**Santa Margarita River
Flood Control Project
MILCON Project P-010**

**Basilone Road Bridge
Replacement
MILCON Project P-030**

**Section 404 Clean Water Act
Draft 404 (b) (1) Analysis and
Public Interest Review for
MILCON Projects P-010
and P-030**

**FINAL
ENVIRONMENTAL IMPACT STATEMENT**

Figure 4.2-1

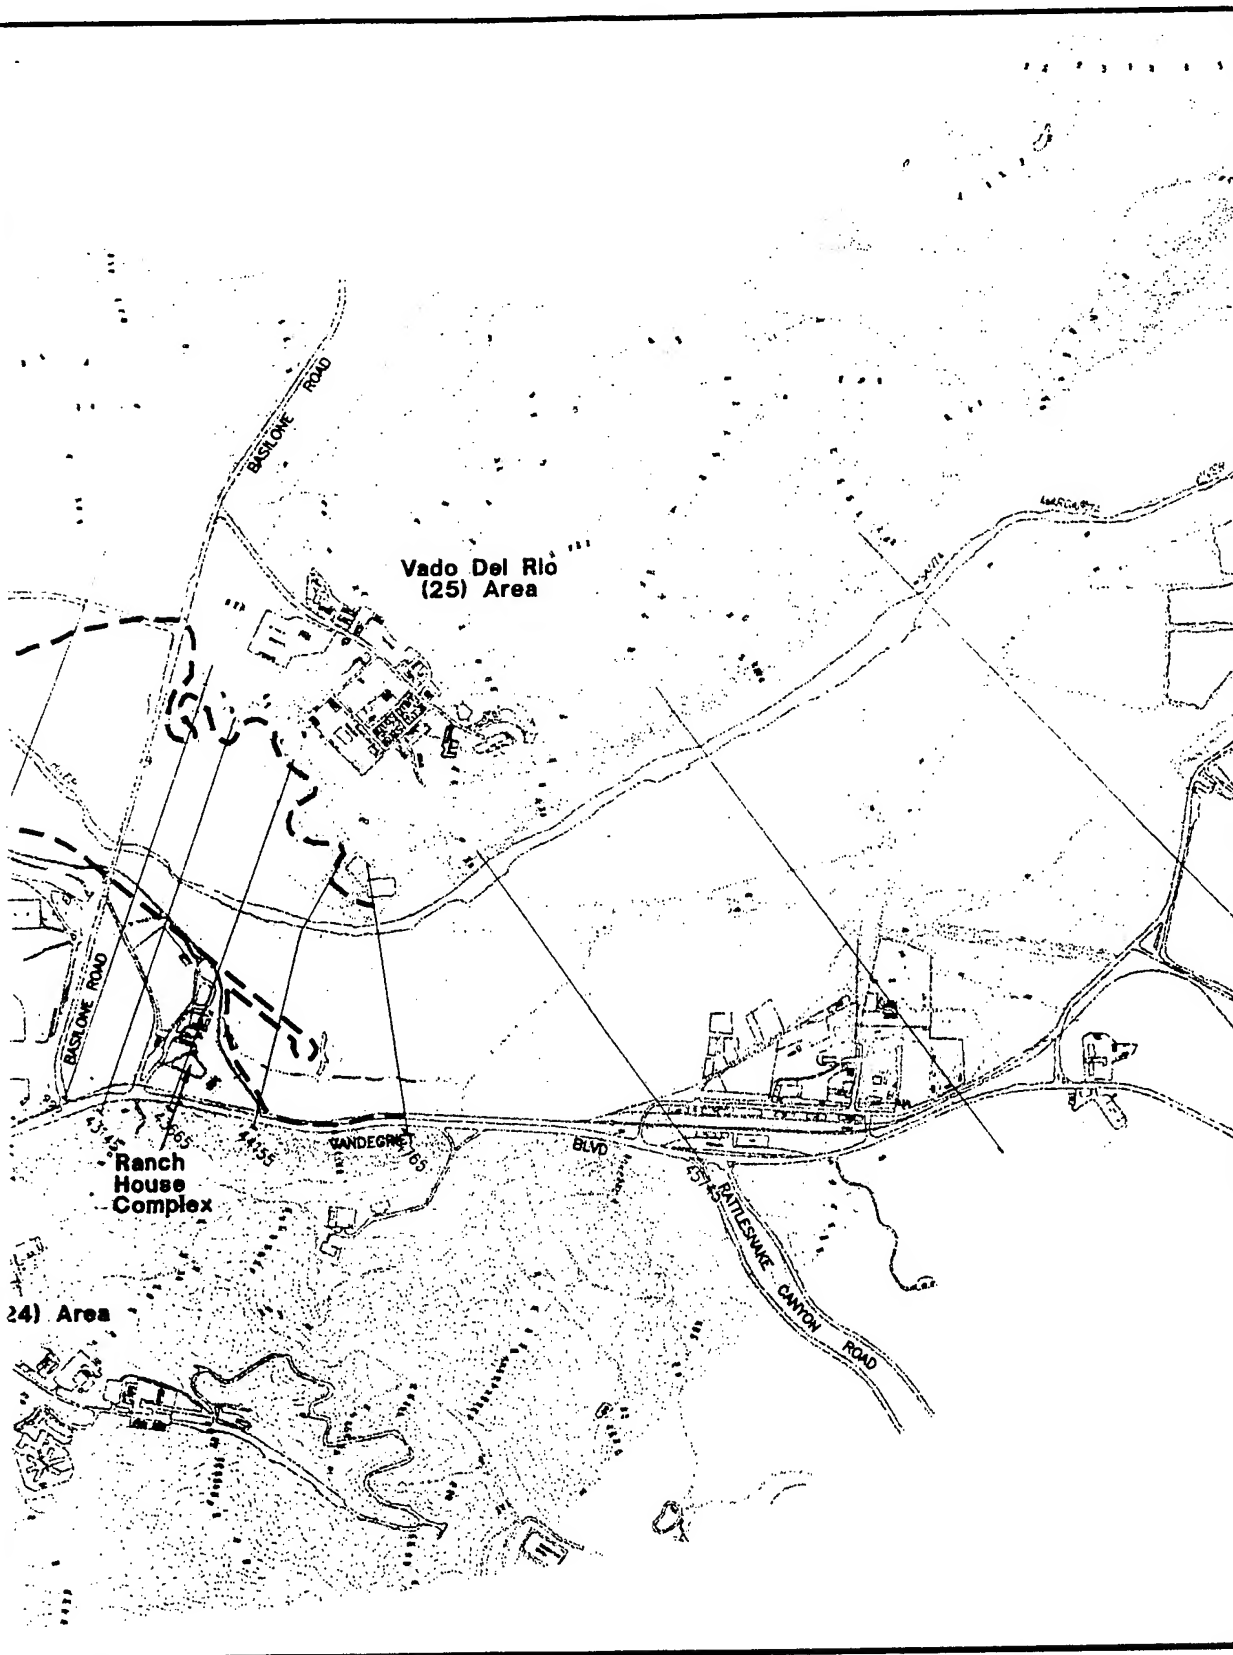
6.17	4	4.2-5	4.1.2.1	4. Page 4.2-5. Under Stormwater Management System it is not clear as to the location of the temporary inundation area "behind" the Chappo (22) area. This should be shown on Figure 4.2-1.	Comment noted. The inundation area is within the Chappo (22) area. Figure 1.2.2 has been edited to show the inundation area. This inundation area is an existing collection basin.
